PLANNING, ZONING, & BUILDING DEPARTMENT
PZ&B Staff Combination Memorandum: Architectural Commission and Town Council

SUBJECT: ARC-23-080 (ZON-23-065) 210 FAIRVIEW RD (COMBO)

MEETING: JUNE 28, 2023 ARCOM
JULY 14, 2023 TC

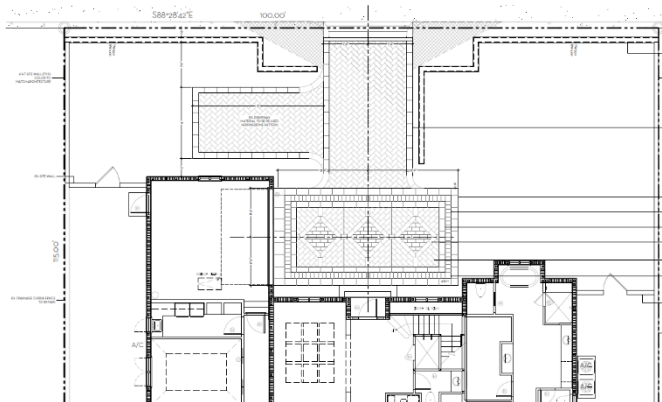
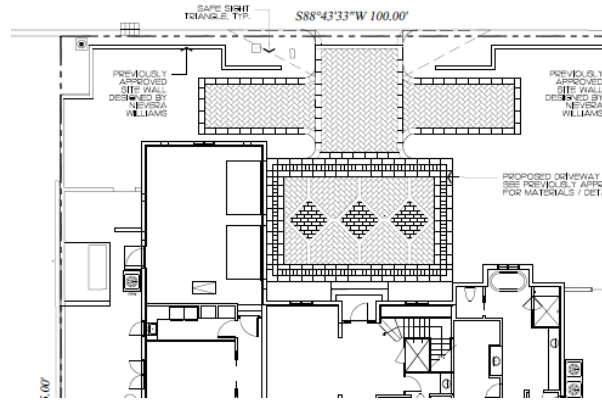
Aside from the garage expansion, no other modifications are proposed for the existing structure. Site improvements, including modifications to site walls, the driveway, and landscaping are requested. Site walls are being readjusted and the driveway apron is being changed to allow for better access into and out of the site. A previously approved parking space on the west of the drive, in front of the garage, is being mirrored to include an additional space on the east side of the entrance to make for a symmetrical design.
